# **DOVER STREET OFFICE DEVELOPMENT** 65-81 DOVER STREET CREMORNE VIC 3121 AUSTRALIA

# TOWN PLANNING APPLICATION PROJECT NO. 190038

#### Agenda Page 34 Attachment 2 - PLN20/0229 - 65 - 81 Dover Street Cremorne - Engineering comments

To:	Lara Fiscalini	
From:	Mark Pisani	
Date:	23 July 2020	
Subject:	Application No: Description: Site Address:	PLN20/0229 9-Storey Office Building 65-81 Dover Street, Cremorne

# Vehicle Crossing – Cross Section

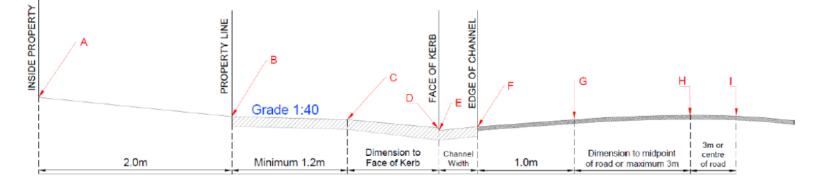
The designer is to submit a 1:20 scale cross section for each proposed vehicle crossing showing the following items:

- A. Finished floor level 2.0 metres inside property
- B. Property line surface level
- C. Surface level at change in grade (if applicable)
- D. Bullnose (max height 60mm) must be clearly labelled
- F. Surface level at the edge of channel
- G. Road level 1.0 meter from the edge of channel

- The maximum allowable cross-fall between points B and C is 1:40 (2.5%).
- A bullnose (max 60mm) is permitted at point D, however not compulsory.
- o The levels shown must be exact reduced levels, to three decimal points. Interpolation of levels is not acceptable.

- The designer must demonstrate that an 85<sup>th</sup> or 99<sup>th</sup> percentile vehicle profile can traverse the design cross section as per the Australian/New Zealand Standard ground clearance template (AS/NZS 2890.1:2004).

Bicycle hoops in Basement Level 1

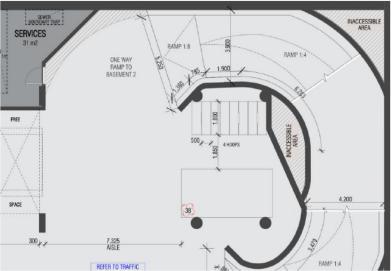
- The location of the four bicycle hoops in basement level 1 (shown in Figure 1 below) does not provide safe access arrangement due to the vehicle ramps at either side and possible blind spot.

- It is recommended that all employee bicycle parking is consolidated into the one secure facility at the ground floor, or at minimum the bicycle parking within the basement level 1 be consolidated into one secure facility and located closer to the lift shaft with unobstructed access;
